Clause 104 Maintenance Requests

Overview

Technical, 802.3bu, Page 53, Figure 104-8

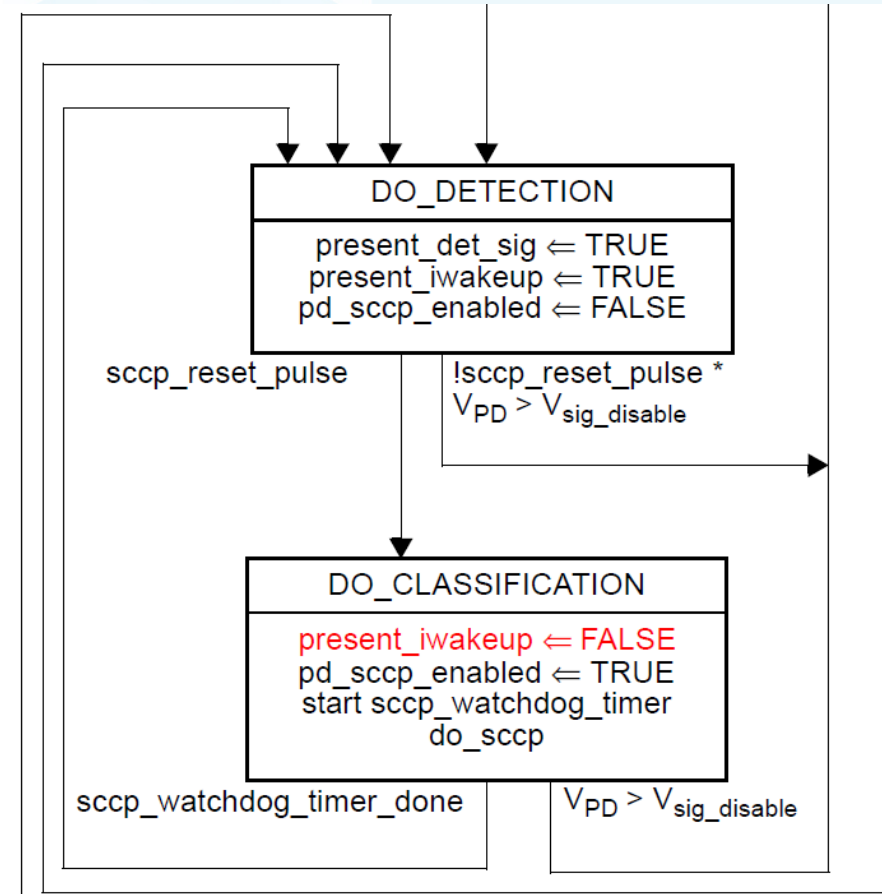
Comment

The PD state machine, as written, requires present_iwakeup to be TRUE in DO_CLASSIFICATION based on an assignment derived from DO_DETECTION. During classification the PD is engaged in SCCP signaling and cannot simultaneously present the iwakeup signature.

Modify Figure 104-8 as follows, specifically setting present_iwakeup to FALSE in DO_CLASSIFICATION.

Technical, 802.3bu, Page 53, Figure 104-8

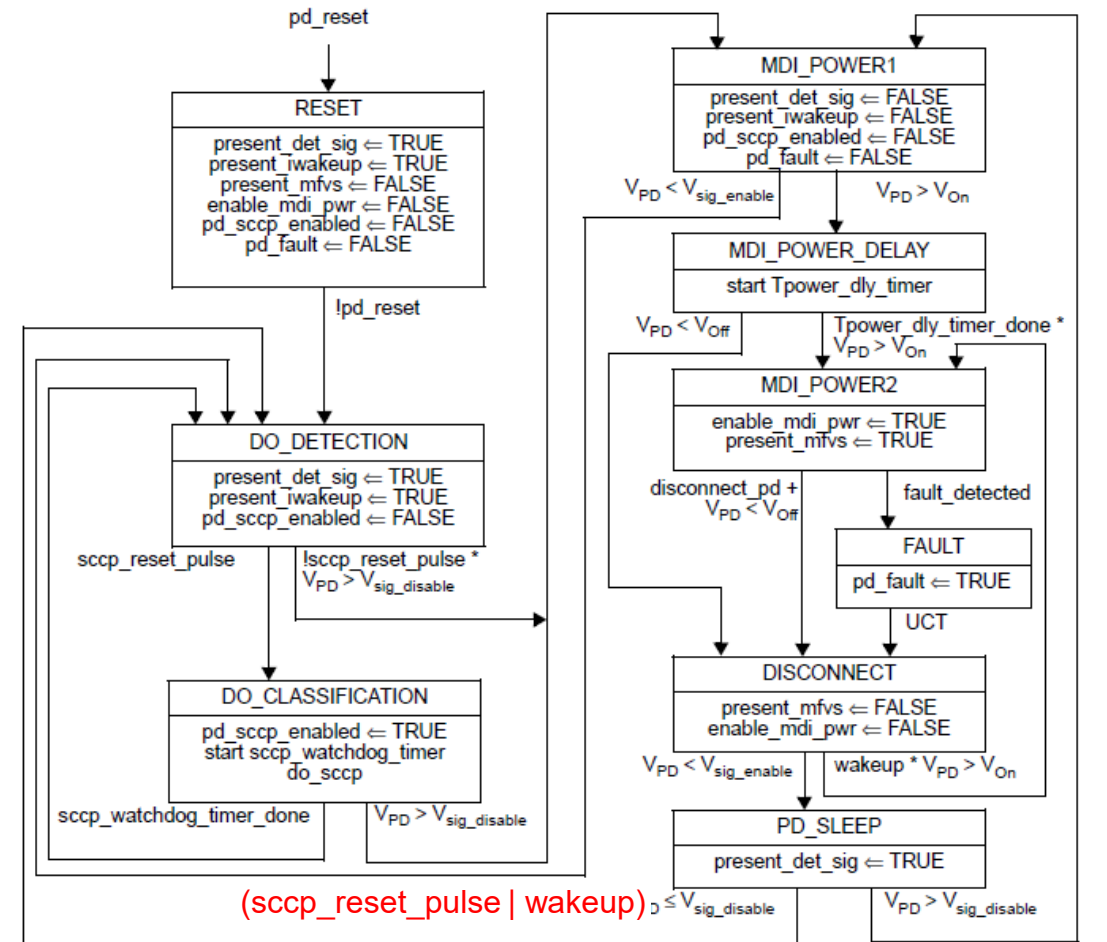
Comment

The PD state machine, as written, does not allow a PD to respond to SCCP classification on PD_SLEEP exit.

Change

wakeup

TRUE: the PD requires the full operating voltage at the PI.

FALSE: the PD is ready to go to sleep.

To

wakeup

An implementation specific variable enabling the PD to request wakeup.

TRUE: the PD requires the full operating voltage at the PI.

FALSE: the PD is ready to go to sleep.

Consider: FALSE: the PD is ready to go to sleep or is not otherwise requesting full operating voltage.
